Somerset County Council

East Taunton Park & Ride

Final Report

January 2007

2.5 Cycle Crossing of Bus & Car Access from A358 West

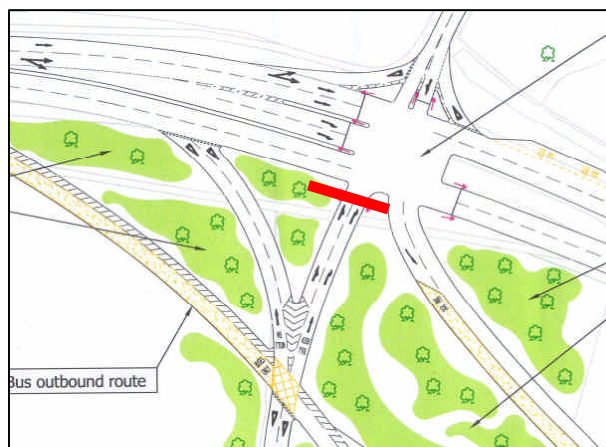
Two traffic lanes are to be crossed and to align a crossing at right angles would create difficulties for the proposed cycle track crossing of the exit road to the west. It is, therefore, considered that the best solution would be to control the crossing of this entry road by traffic signals with a crossing point that aligns with that provided for the adjacent exit road.

This would also make conditions safer than the provision of an un-signalled crossing by removing the need for those wishing to cross to decide whether traffic emerging from Ruishton lane is going to accelerate across the A358 to enter the site. If this solution is adopted then cyclists, and pedestrians, will be able to call a green signal to cross whenever the following phases are running:

As an alternative, an un-signalled crossing point could be created some way back from the A358 further along the access road. To ensure low speeds on the access road the crossing would need to be sited on a speed table. However, this would also not sit well with traffic accelerating across the junction to enter the site nor would it be desirable on the return bus route. Such a solution would also have the knock-on effect of moving south the crossing of the exit slip road immediately to the west. As a consequence, this would probably place that crossing point within the stacking lanes provided for traffic queuing to leave the site and is not recommended.

Recommendation: Site the crossing point close to the main carriageway, align it with the crossing point immediately to the west and control with signals (see also 2.21 Cyclist detection).

Indicative sketch only – not to scale

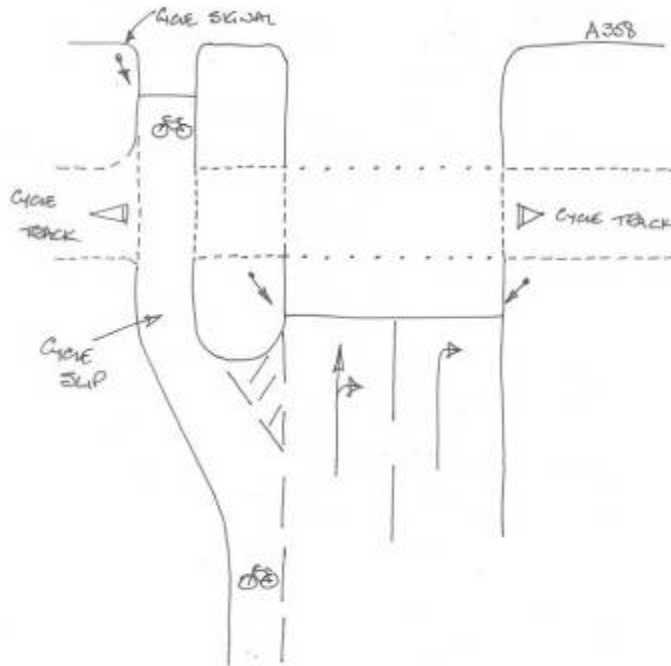
To accommodate the cyclist traffic that i) wishes to leave the body of the park and ride site or ii) turn left from the cycle track to travel towards Ruishton Lane across the A358 on the carriageway, it is suggested that this is best achieved by a separate signalled slip to the west of the nearside signal for emerging car traffic. This would create a left turn off of the cycle track. Cyclists who have been using the cycle parking within the site and who then wish to leave to join Ruishton Lane, should have a cycle lane provided to reach this separate signal (see indicative sketch below). Pedestrians and cyclists crossing the cycle slip should be required to give way to both cyclists and car traffic leaving the site.

Clearly this solution pulls back the stop line for emerging motorists but it is only marginally further back than would result from the inclusion of a full depth ASL (5m – see Diagram 1001.2 TSRDG). This has benefits in that it places cyclists ahead of other traffic where it can be seen and enables it to get ahead of other traffic in the same way as a normal advanced stop line. The resulting island should be wide enough to accommodate a cyclist waiting to cross the exit road (2.5m). Cyclists should be detected both by their presence at the stop line, having turned off the cycle track, and on the approach to the signal along the cycle lane.

Note: crossing shown as cycle track giving way to exiting motorists and cyclists – this would minimise delay for those crossing.

Recommendation: Crossing layout is created in the form shown in above sketch.

2.7 Crossing of Give-Way Exit Road for Cars

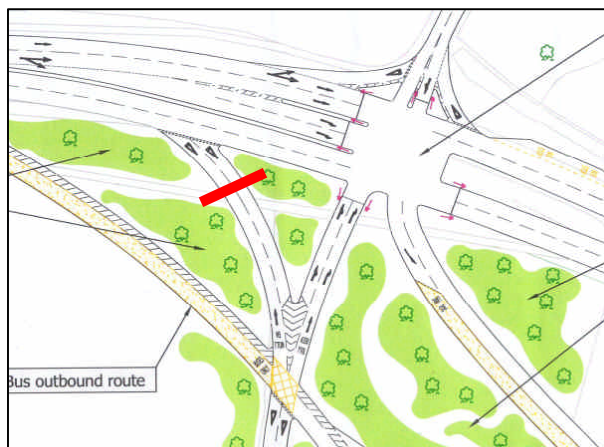
The safe crossing of this road should be delivered by creating a ramped crossing at right angles to the exit road with adequate visibility splays provided in the same style as 2.2 above.

Recommendation: Create crossing at right angles to the exit road on raised table and investigate the possibility of providing a cycle priority crossing during the detailed design process.

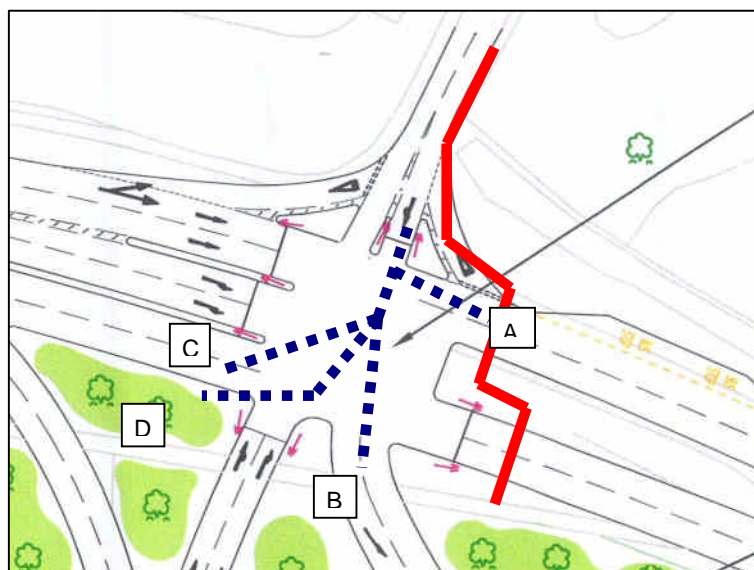
In addition, if a crossing is provided in the suggested position shown as a red line on the above extract of the draft scheme drawing, the presence of the left slip will add to the difficulties faced by pedestrians needing to pass through this junction in order to get to it. However, it is not recommended that the need to cross the A358 is accommodated to the west of the Ruishton Jane junction to avoid this situation. This is because the additional crossing length, and the need for wider central refuges will create a considerable delay for those crossing, a longer detour for pedestrians wishing to get to the park and ride site from Ruishton Lane and possibly an adverse impact on overall junction capacity if it interferes with the car traffic leaving the park and ride site and heading west.

On balance, it is therefore considered that the best solution is for the left turn slip to be abandoned and for the provision of a signal controlled crossing that utilises the wide central margin and allows less confident or more vulnerable cyclists to cross with pedestrians. It should be noted that cyclists using this crossing who wish to enter the site to take advantage of the 'bike and ride' opportunity will probably want to cycle along the link from the bus stop on the southern side of the A358 as recommended in 2.4 above to avoid mixing with motor traffic (see also 2.32 ii D below).

Recommendation: reconsider the provision of the left turn slip from Ruishton Lane and provide a signal controlled crossing for both pedestrians and cyclists of the A358 immediately to the east of the junction. Create a cycle track on the eastern side of Ruishton Lane to provide access to this crossing.

Indicative sketch layout for separately signalled cycle exit from Ruishton Lane with banned left turn out

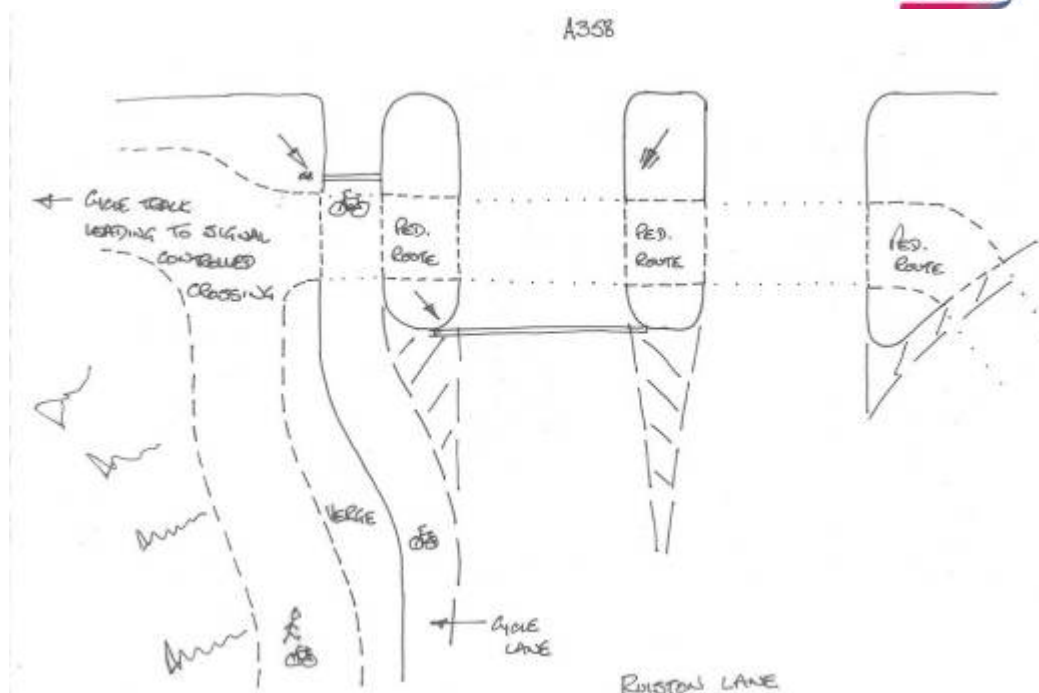
Alternatively, the cycle track referred to above could also feed into a separately signalised advance position similar to that suggested in 2.6 above (see indicative sketch below). To be effective, this junction treatment would probably require the banning of the left turn out of Ruishton Lane for motor traffic. This would result in the need for this traffic to turn right and go around the roundabout before heading east (or go via routes to the east) but it is felt that the volumes concerned would not have an adverse impact on capacity at the roundabout.

Recommendations: An advanced stop line should be provided for cyclists emerging from Ruishton Lane. Ruishton Lane should be widened to provide a lead-in cycle lane on the approach to the ASL. Alternatively a separately signalled advance cycle stop line be provided accompanied by a left turn ban (investigation of this solution is strongly recommended). Cycle access to the cycle track on the southern side of the A358 should be provided to allow cyclists emerging from Ruishton Lane on the carriageway to leave the carriageway.
